OC PLANNING REPORT

SUBJECT: Public Hearing on Planning Application PA20-0089 for a Use Permit and Variance

PROPOSAL: A request for a Use Permit and Variance for deck and wall improvements at an existing residence. A Use Permit is required for the construction of a service yard screen wall at a height of 9 feet within the front setback where Zoning would otherwise permit a maximum height of 3 feet 6 inches. A Variance is required to allow for a reduced front setback of 5 feet 9 inches for a new deck and support columns where the Zoning Code would otherwise require 16 feet 11.6 inches pursuant to the shallow lot provisions of the Code. The screen wall and deck support columns would generally match the existing front setback. Minor grading relating to the proposed improvements would also be proposed.

LOCATION: The project is located in the community of Emerald Bay at 522 Emerald Bay, Laguna Beach, CA within the Fifth Supervisorial District (APN 053-081-05).

Variance – Front yard setback

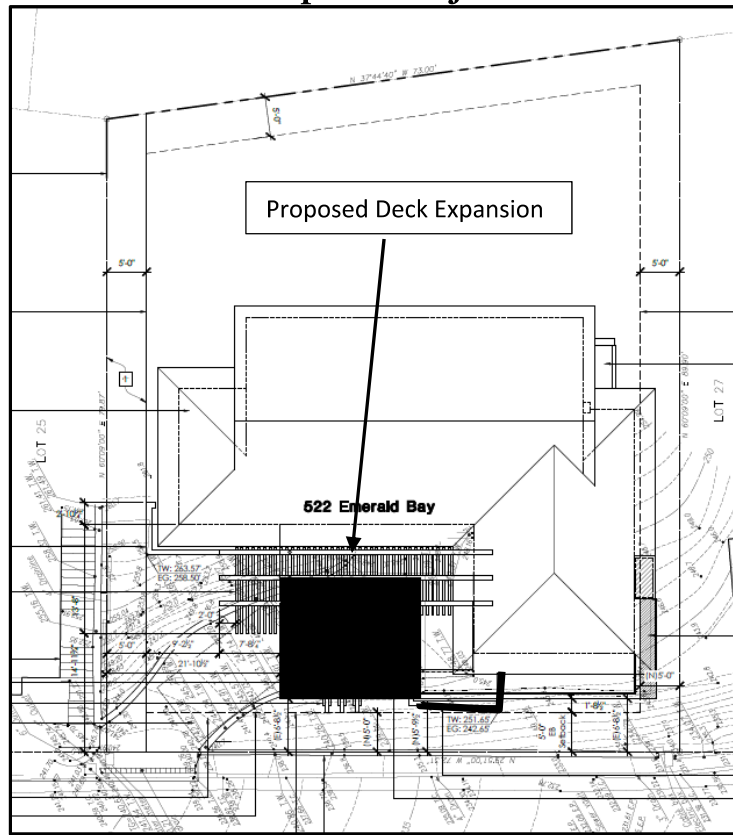
The subject property qualifies as a shallow lot with an average depth of 84 feet 10 inches. This would permit a rear setback of 16 feet 11 inches (20% of 84 feet 10 inches). The project proposes a 5-foot 9-inch setback for the support columns for the deck expansion. It is noted that the proposed support columns would be in line with the existing conforming setback of the garage area and living space above it.

Proposed Over-Height Screen Wall

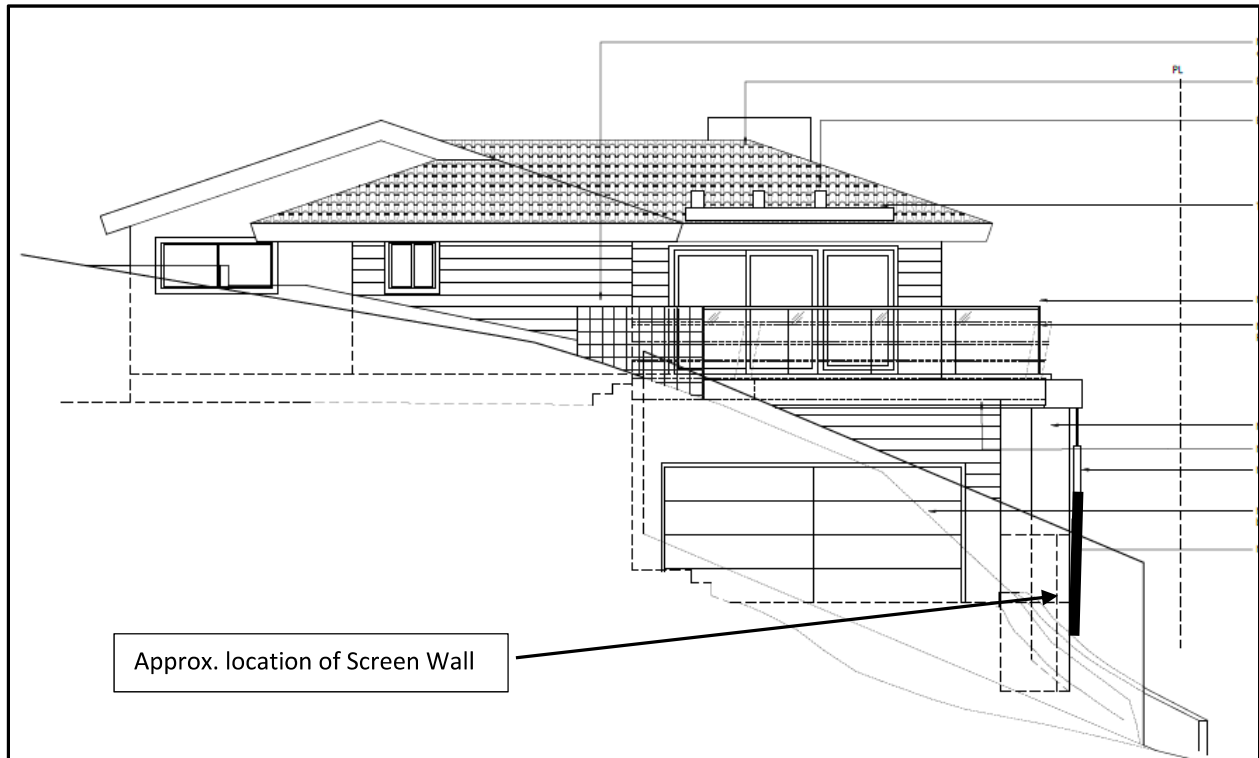
The proposed project design also includes a screening wall for a new service area that will be located adjacent to the existing garage entry and within the front yard setback. Due to the topography of the site dropping quickly from the proposed location down to the fronting street,

the screening wall would have a measured height of up to 9 feet.

The proposed wall will be located above and parallel to property lines along the street and will not result in or create a traffic hazard. The location, size and design of the walls are consistent with similar improvements throughout Emerald Bay and will not be objectionable, detrimental or incompatible with other permitted uses within the community. Staff recommends that the two required findings to modify permitted wall height can be made. Recommended findings are included in Attachment 1.
